STAFF DEVELOPMENT REVIEW COMMITTEE MEETING MINUTES

APPLICATION: Planned Commercial Development Rezoning/All Aboard Storage
Taylor Road
CASE NO.: 19-65000003
LOCATION: 1673 Taylor Road

**PCD REZONING/
ALL ABOARD STORAGE TAYLOR ROAD
CASE NO. 19-65000003
OUTSTANDING TECHNICAL COMMENTS AS OF OCTOBER 4, 2019**

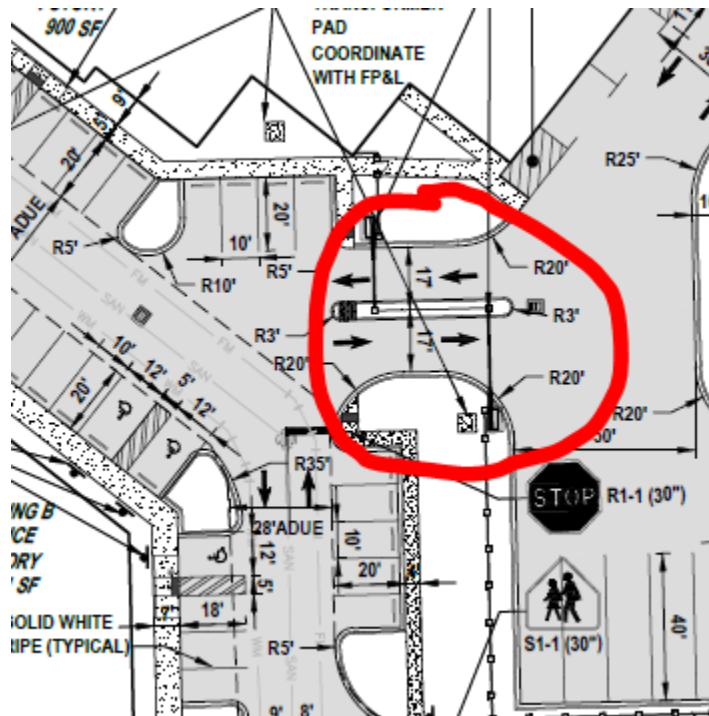
1. Need 20' clear access into the storage area per NFPA 1, Ch. 18 (FD Access and Water Supply) states there must be a minimum of 20' clearance for FD access. See snippet below:
